IEEE 1914 NGFI

IEEE 1914.3a RoE – Change Summary for Draft D1.4

Richard Tse, Microchip Technology

Dec 1, 2020

Clause 13 – Proxy Follower State Machine

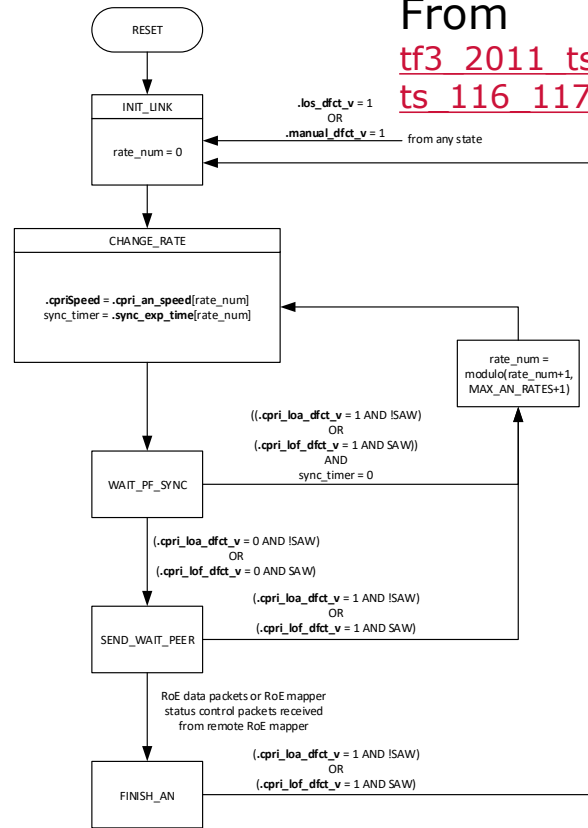
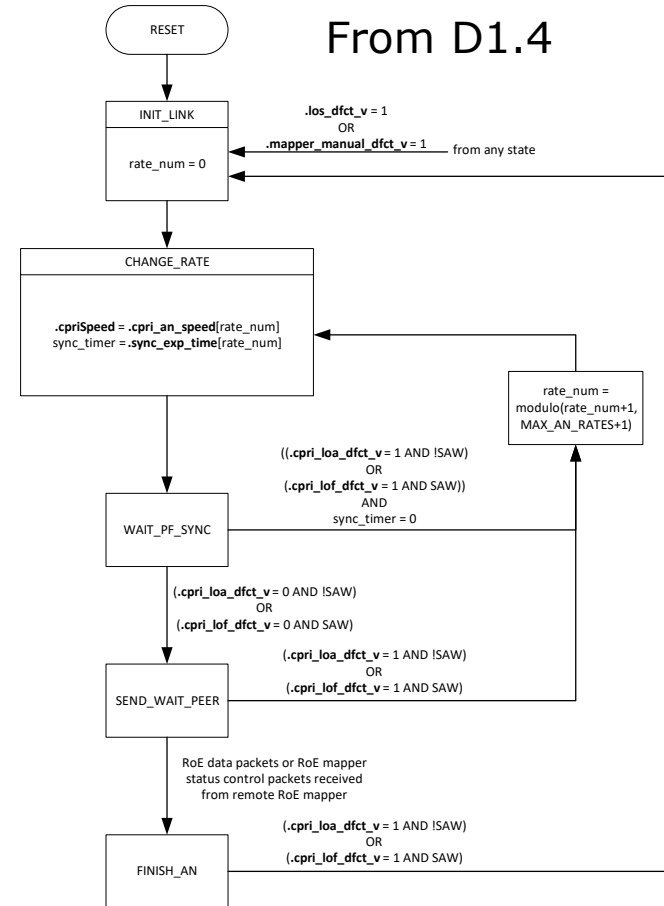
- Clause 13 – many changes for autonegotiation
 - Changes as per meetings on Oct 20 and Nov 3, 2020 were made
 - The following additional changes were made:
 - Table 34 was removed as the parameters it used to contain were found to no longer be needed
 - In the RoE Proxy Leader autonegotiation state machine shown in Figure 35
 - The transition from SEND_CPRI state to the SEND_RPL_PATT state was removed. The editor believes a change in CPRI rate is first identified by one of the defects that move this state-machine to the SEND_RPL_PATT state.
 - The INS_RPL_PATT state was removed. The editor believes the conditions related to this state are not part of the autonegotiation state machine. They are, instead, part of the defect handling mechanism. A state like INS_RPL_PATT does not exist in the Proxy Follower state machine.
